Midpeninsula Regional
Open Space District

R-23-101
Meeting 23-26
September 13, 2023

Actions to Address Additional Slope Failure Repairs as part of the Lower Alpine Road Retaining Wall Project at Coal Creek Open Space Preserve

Addendum to the Project Initial Study / Mitigated Negative Declaration

FIGURE 4

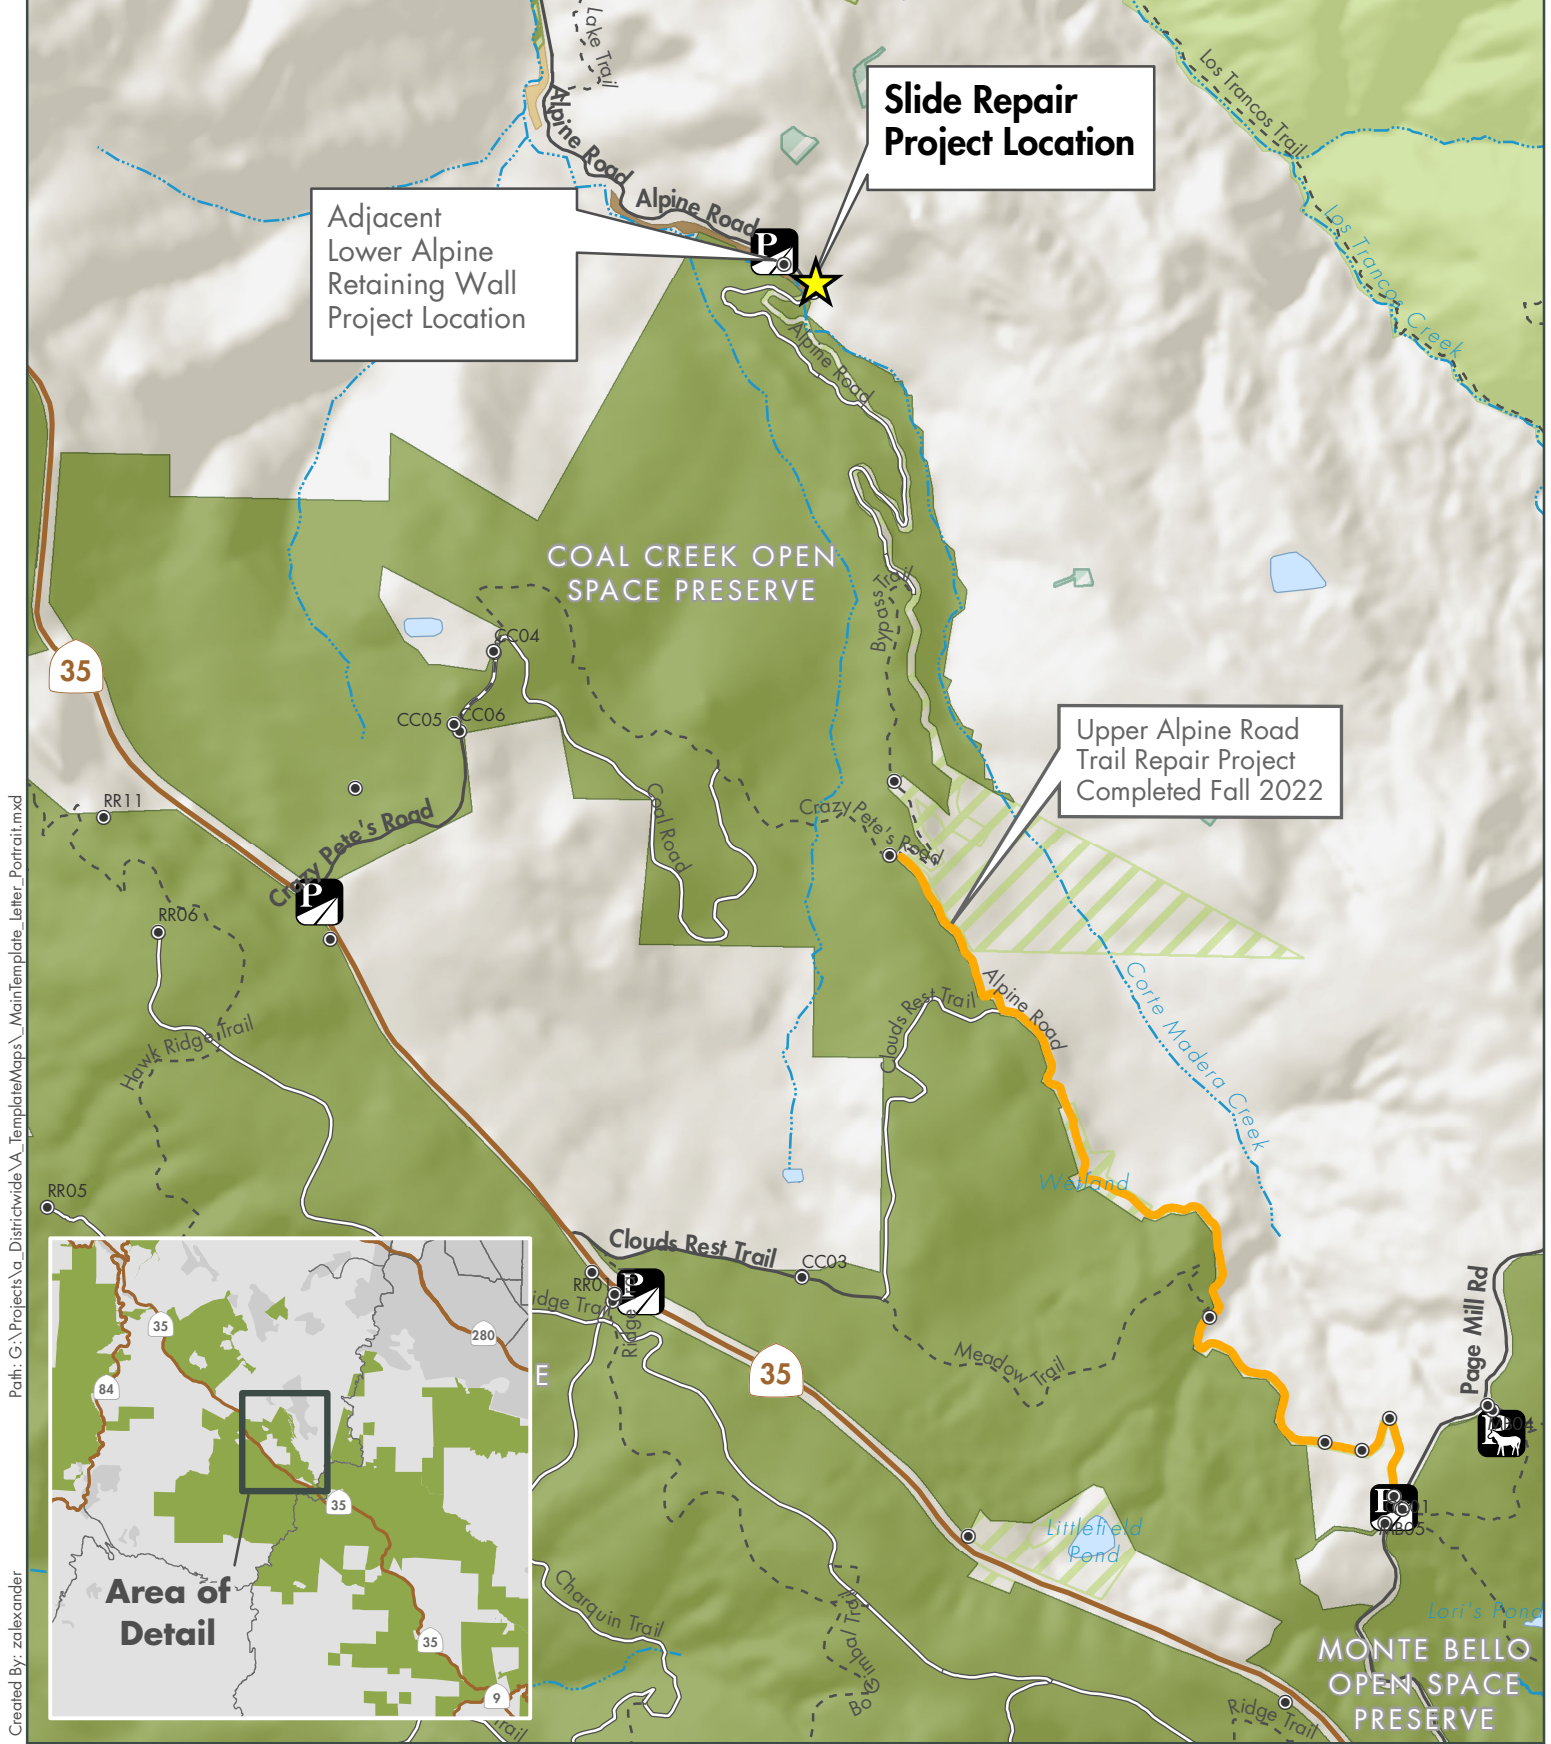
The revised project includes one additional slide repair along Alpine Road Trail immediately upstream of the Site #21 project site on Corte Madera Creek, within the San Francisquito Creek Watershed. Grading activities would occur to establish construction access to the repair site, remove loose and soft debris from the scarp³ footprint, and to establish minor benches. It is anticipated that an approximately 600-square-foot temporary impact area would be required for staging and access to the repair site and the area of excavation would be approximately 817 square feet. Excavation at the site would result in approximately 140 cubic yards of cut material and approximately 165 cubic yards of fill material, 6 cubic yards would be placed below the Ordinary High Water (OHW) line and 159 cubic yards above the OHW line. Rock slope protection would be placed in the scarp footprint, capped with native soils and erosion control protections. The proposed slide repair would also require the

removal of one tree, a California bay laurel (*Umbellularia californica*), which is considered an upland tree. The remainder of the slide repair area consists of bare ground and does not contain any vegetation. The design of the additional slide repair is provided in Figure 4.
